Appliance Standards Awareness Project  
American Council for an Energy-Efficient Economy  
Consumer Federation of America  
National Consumer Law Center  
Natural Resources Defense Council

November 28, 2022

**RE: Docket Number EERE-2022-BT-STD-0002: Energy Conservation Standards for Fans and Blowers**

**Figure 1:** FEI as a function of fan diameter for ACFs in the BESS database (hollow blue circles) and DOE's evaluated ELs (solid circles/lines).

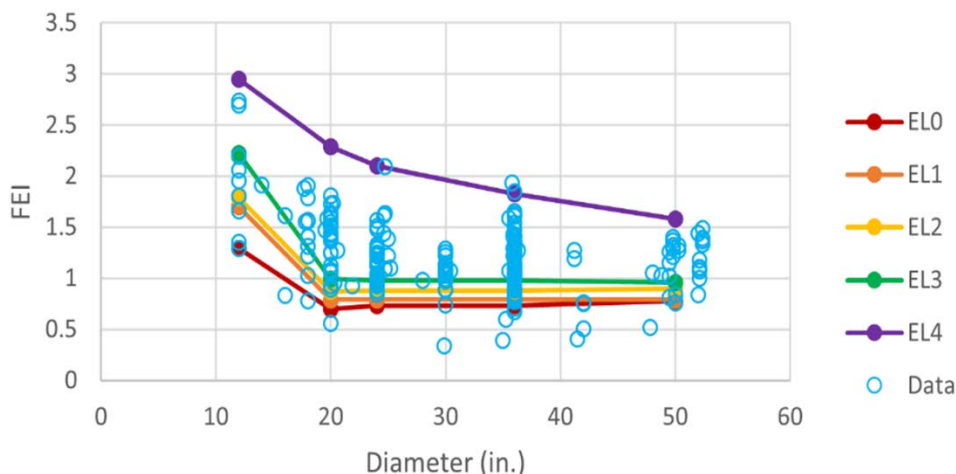
**We encourage DOE to consider additional ELs that better represent the range of ACF FEIs presented in the NODA.** DOE analyzed four ELs, with EL1, EL2, and EL3 reflecting improved motor efficiency (from split-phase to ECM) and the maximum technologically feasible (max-tech) EL4 level representing an ACF with an ECM and aerodynamic redesign. This approach resulted in a relatively narrow range of FEIs from EL0 to EL3. For example, FEI for the 24" 0.5 hp representative unit (RU) increases by about one-third from EL0 (FEI = 0.73) to EL3 (FEI = 0.98). In comparison, efficiency more than doubles going from EL3 to EL4 (FEI = 2.10). DOE's approach, focusing primarily on improved motor efficiency, appears to be in response to feedback from manufacturers who stated a preference for improving fan efficiency via improved motor efficiency rather than aerodynamic redesign. However, the ELs presented in the NODA do not appear to be representative of the fan efficiency distribution in the BESS database. As shown in Figure 1 (copied from DOE's Fans NODA Engineering Analysis Spreadsheet<sup>2</sup>), the majority of ACFs analyzed in the NODA have FEIs between EL3 and EL4. Importantly, the large range of FEIs in between EL3 and EL4 are for ACFs that presumably all utilize PSC motors.<sup>3</sup> Overall, the broad range of FEIs observed in DOE's analysis of the BESS database fans suggests that the Department's efficiency levels may not be accurately capturing the range of efficiencies available on the market. Thus, we encourage DOE to consider one or more additional ELs between EL3 and EL4 that would better reflect the spread of ACF FEIs in the BESS database.
